Attachment E

From: Kenneth A. Vest <KVest@BrwnCald.com>
Sent: Monday, August 12, 2019 9:16 AM
To: David O Simmons <david.simmons@phoenix.gov>
Cc: KENNETH VEST <vest379@outlook.com>
Subject: Rezoning Case Z-33-19

ZONING CASE Z-33-19-1

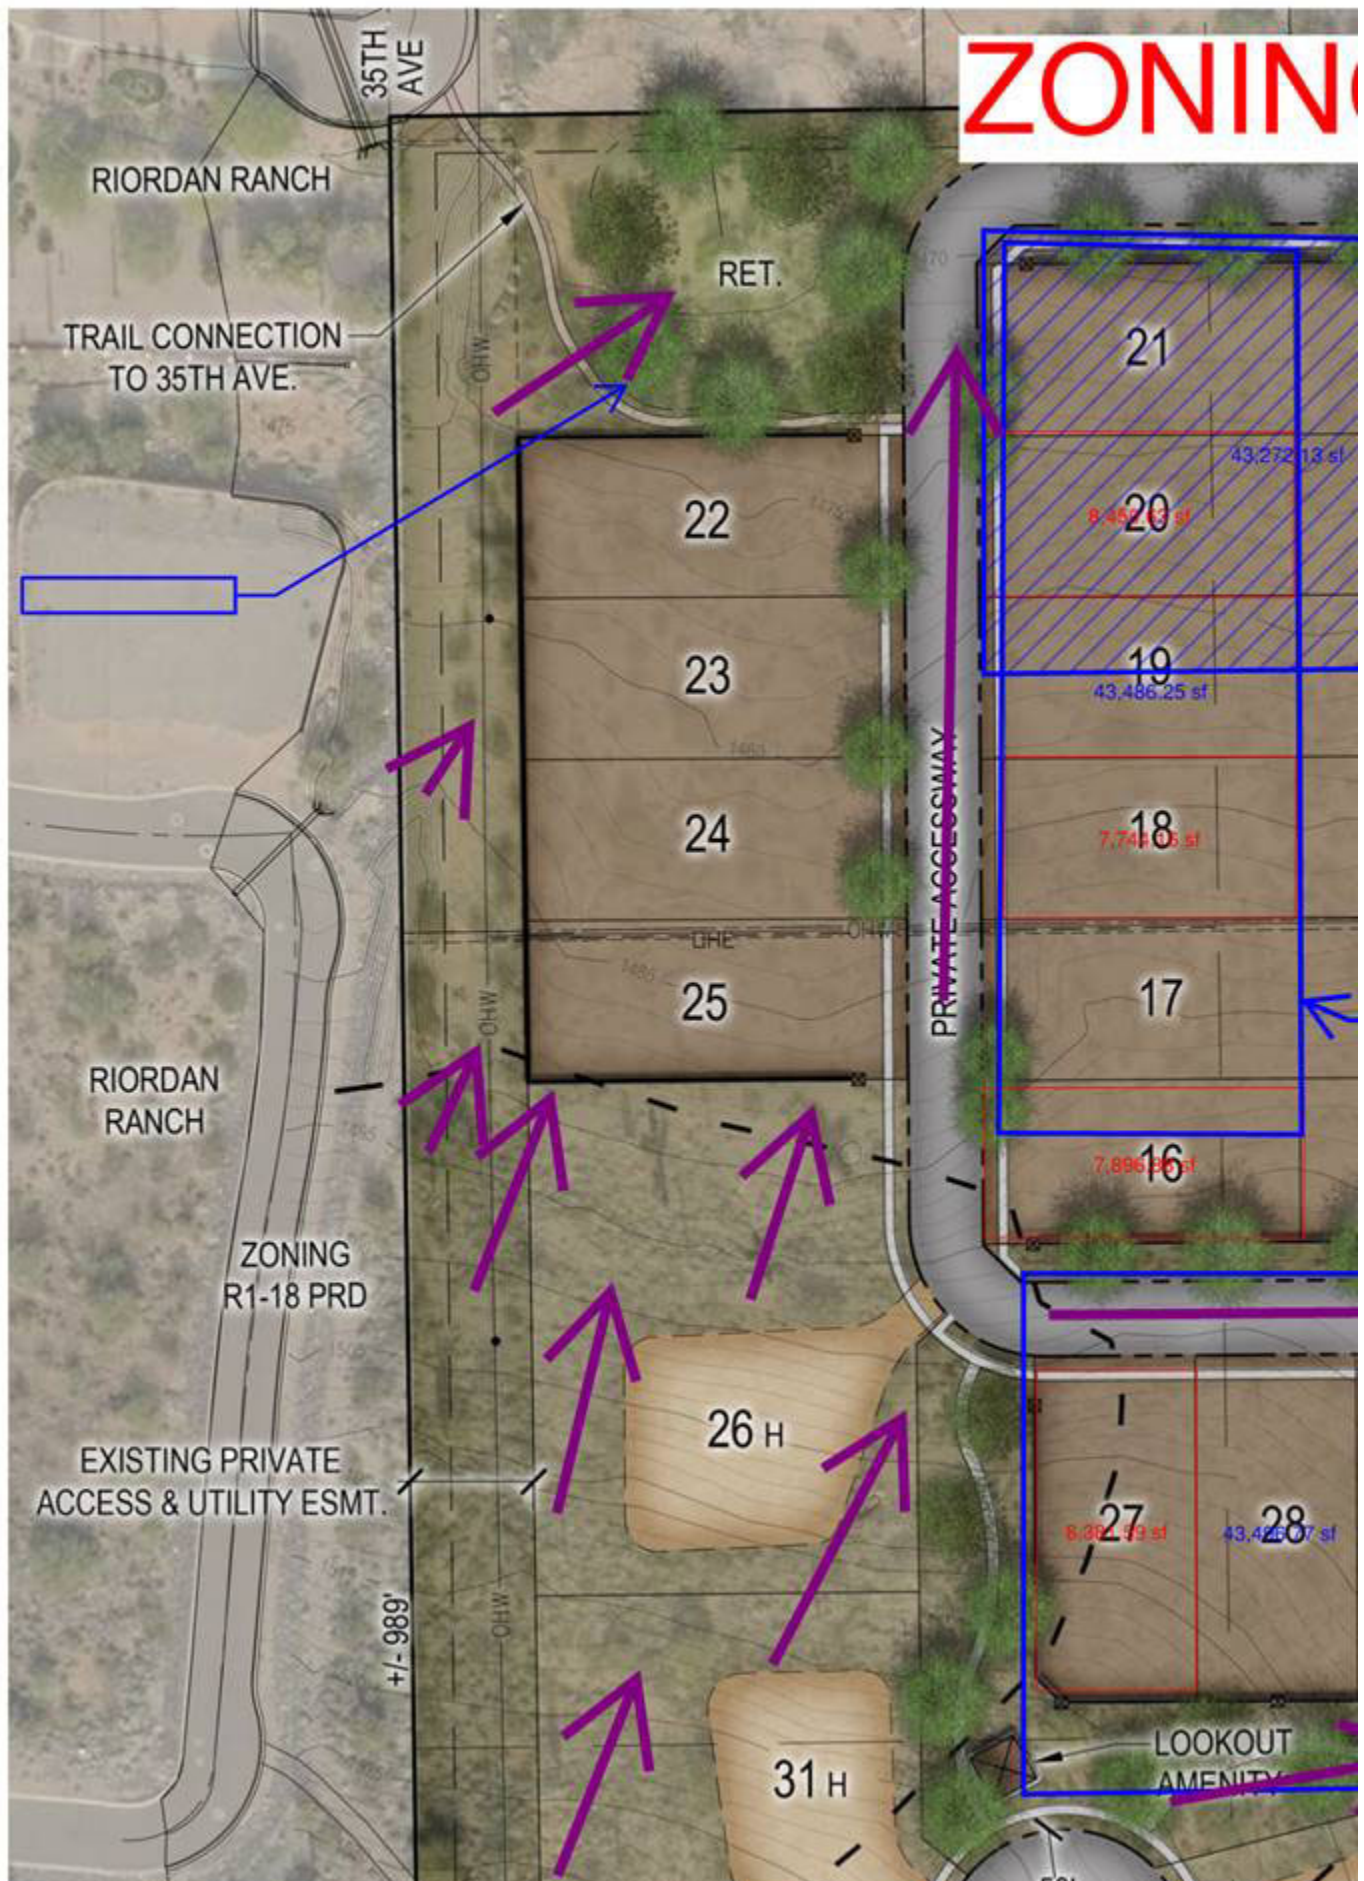
- PROPOSED DENSITY EXCEEDS GENERAL PLAN (37/18 > 2.0 units/acre)

- LOTS DO NOT CONFORM TO HILLSIDE DEVELOPMENT REQUIREMENTS FOR DENSITY (1.8 units/acre) BUT CLAIM TO BE A PLANNED DEVELOPMENT TO MEET R-1-18 DENSITY IN EXCESS OF 1.95 units/acre. EITHER WAY OR THE OTHER, THE PLANNED DEVELOPEMENT EXCEEDS DENSITY REQUIREMENTS.

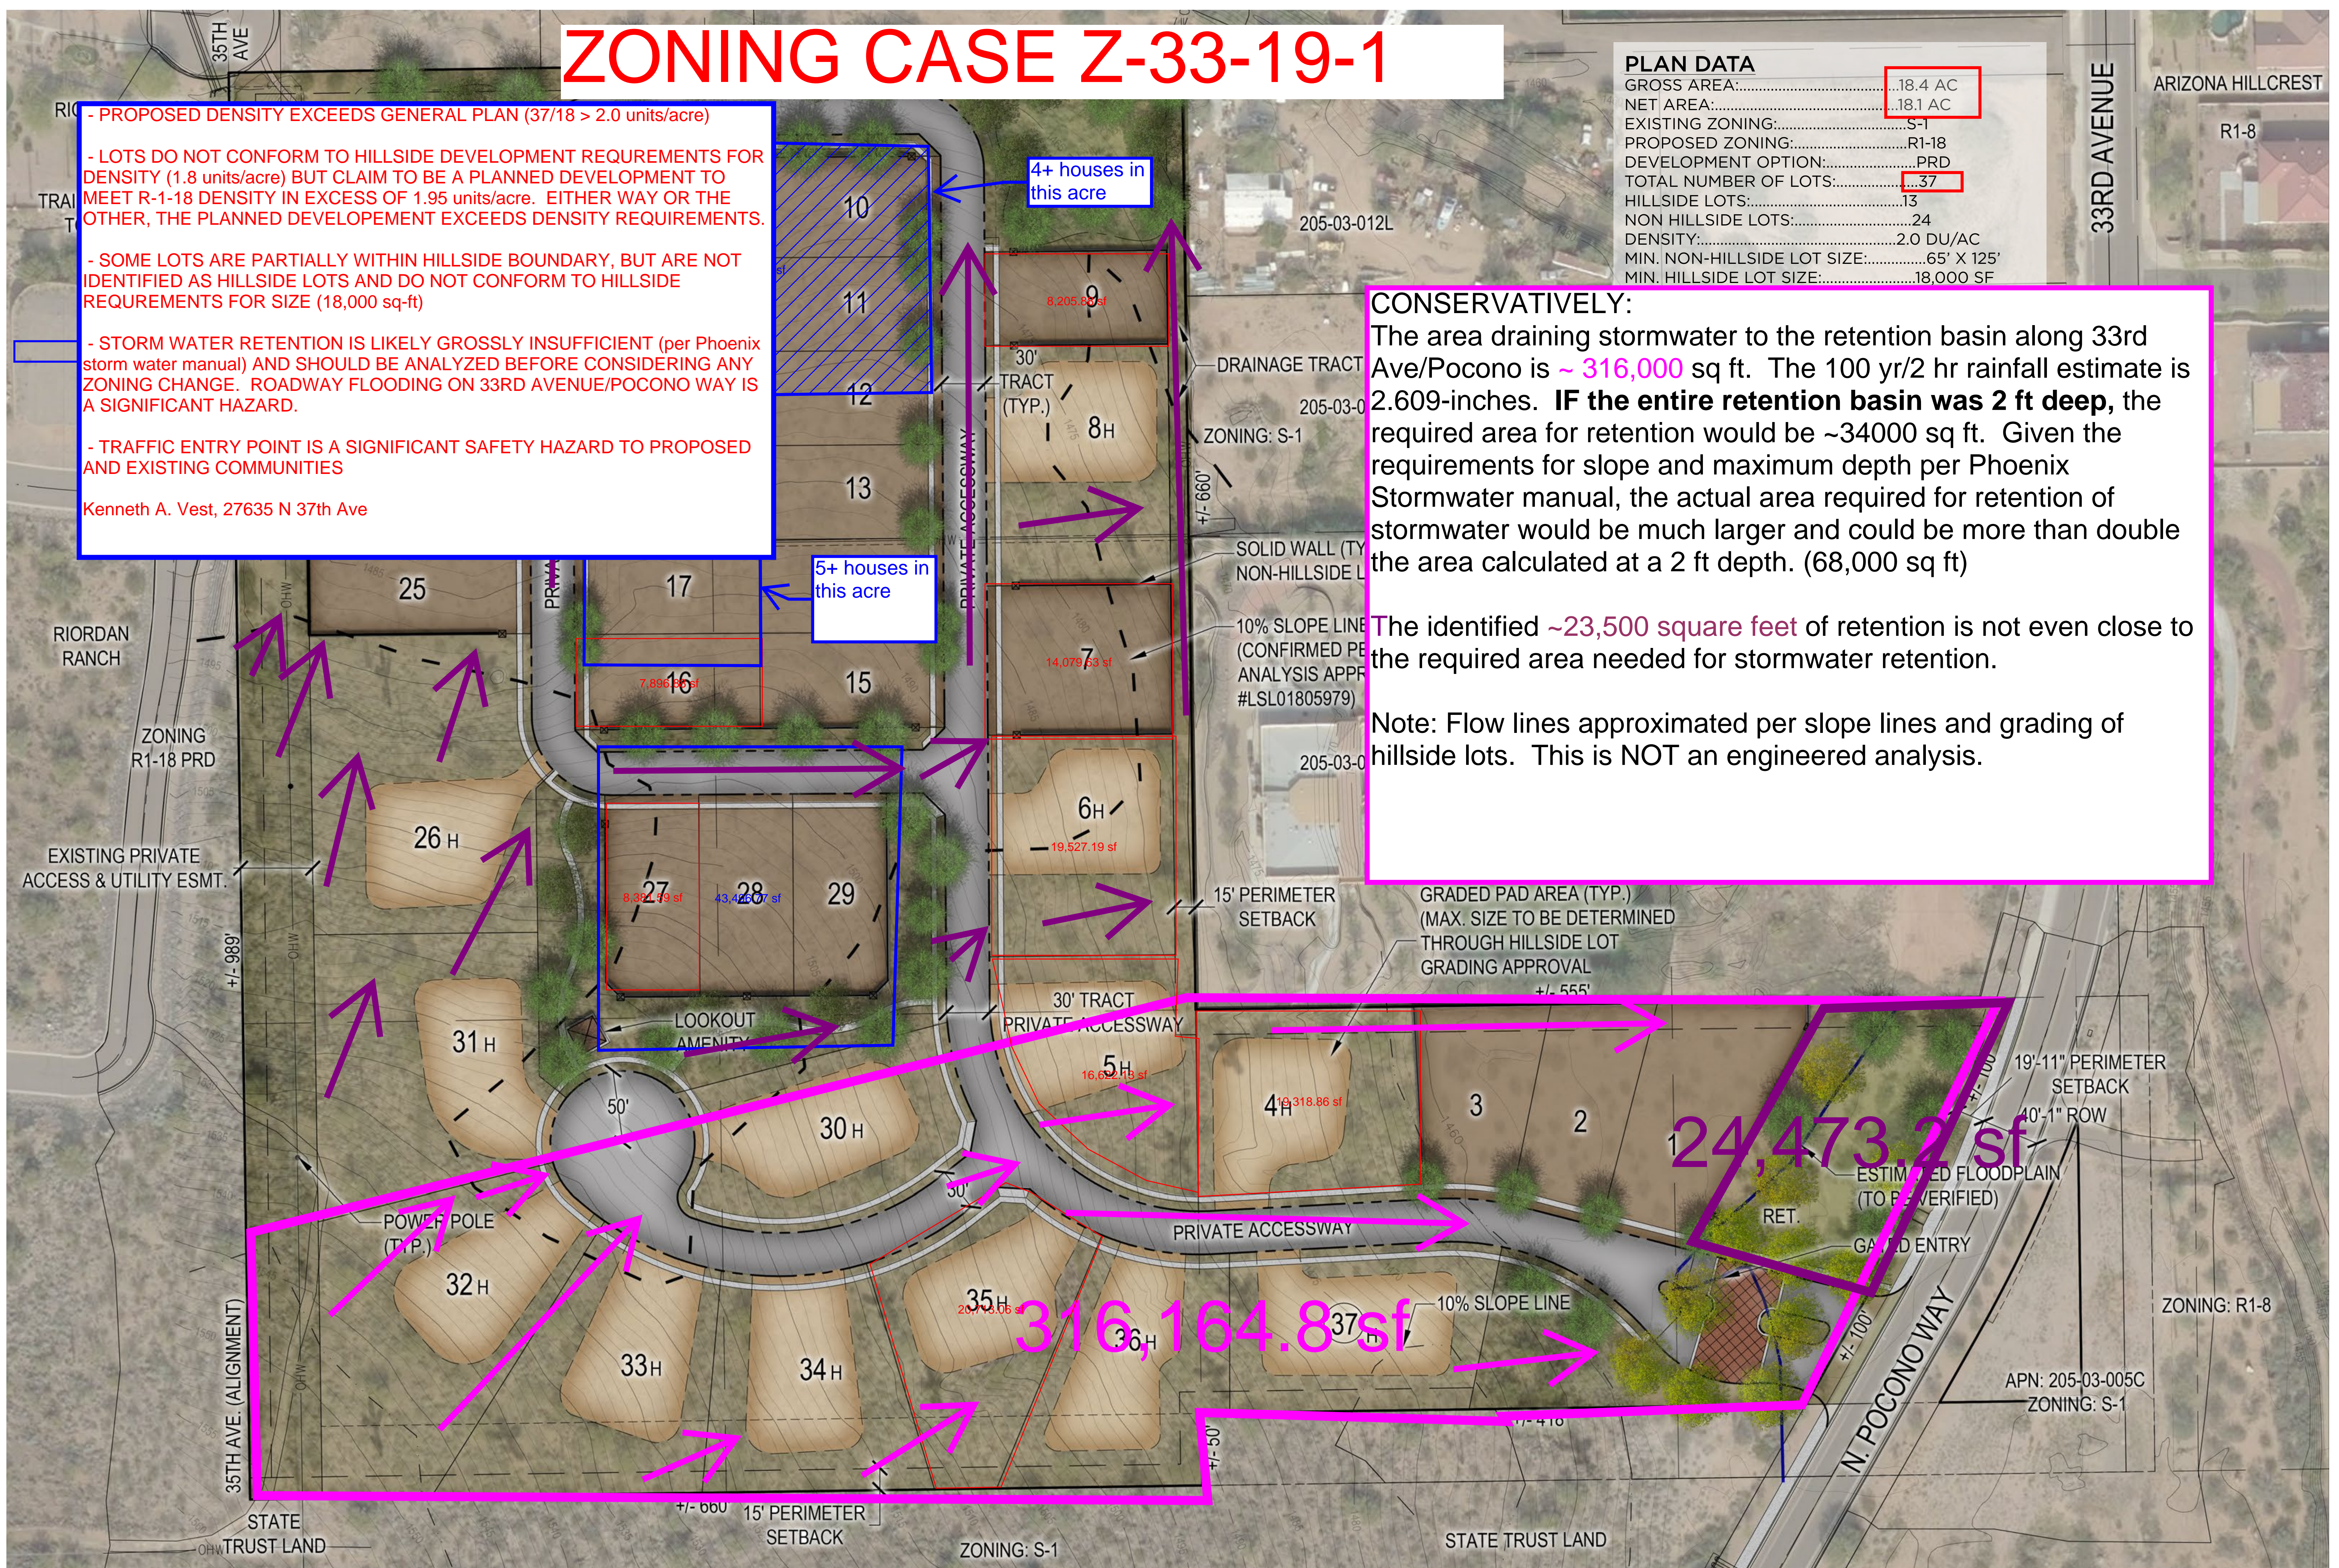
- SOME LOTS ARE PARTIALLY WITHIN HILLSIDE BOUNDARY, BUT ARE NOT IDENTIFIED AS HILLSIDE LOTS AND DO NOT CONFORM TO HILLSIDE REQUIREMENTS FOR SIZE (18,000 sq-ft)

- STORM WATER RETENTION IS LIKELY INSUFFICIENT (per Phoenix storm water manual) AND SHOULD BE ANALYZED BEFORE CONSIDERING ANY ZONING CHANGE. ROADWAY FLOODING ON 33RD AVENUE/POCONO WAY IS A SIGNIFICANT HAZARD.

- PROPOSED DENSITY EXCEEDS GENERAL PLAN (37/18 > 2.0 units/acre)
 - LOTS DO NOT CONFORM TO HILLSIDE DEVELOPMENT REQUIREMENTS FOR DENSITY (1.8 units/acre) BUT CLAIM TO BE A PLANNED DEVELOPMENT TO MEET R-1-18 DENSITY IN EXCESS OF 1.95 units/acre. EITHER WAY OR THE OTHER, THE PLANNED DEVELOPEMENT EXCEEDS DENSITY REQUIREMENTS.
 - SOME LOTS ARE PARTIALLY WITHIN HILLSIDE BOUNDARY, BUT ARE NOT IDENTIFIED AS HILLSIDE LOTS AND DO NOT CONFORM TO HILLSIDE REQUIREMENTS FOR SIZE (18,000 sq-ft)
 - STORM WATER RETENTION IS LIKELY GROSSLY INSUFFICIENT (per Phoenix storm water manual) AND SHOULD BE ANALYZED BEFORE CONSIDERING ANY ZONING CHANGE. ROADWAY FLOODING ON 33RD AVENUE/POCONO WAY IS A SIGNIFICANT HAZARD.
 - TRAFFIC ENTRY POINT IS A SIGNIFICANT SAFETY HAZARD TO PROPOSED AND EXISTING COMMUNITIES
- Kenneth A. Vest, 27635 N 37th Ave

The area draining stormwater to the retention basin along 33rd Ave/Pocono is ~ 316,000 sq ft. The 100 yr/2 hr rainfall estimate is 2.609-inches. **IF the entire retention basin was 2 ft deep**, the required area for retention would be ~34000 sq ft. Given the requirements for slope and maximum depth per Phoenix Stormwater manual, the actual area required for retention of stormwater would be much larger and could be more than double the area calculated at a 2 ft depth. (68,000 sq ft)

The identified ~23,500 square feet of retention is not even close to the required area needed for stormwater retention.
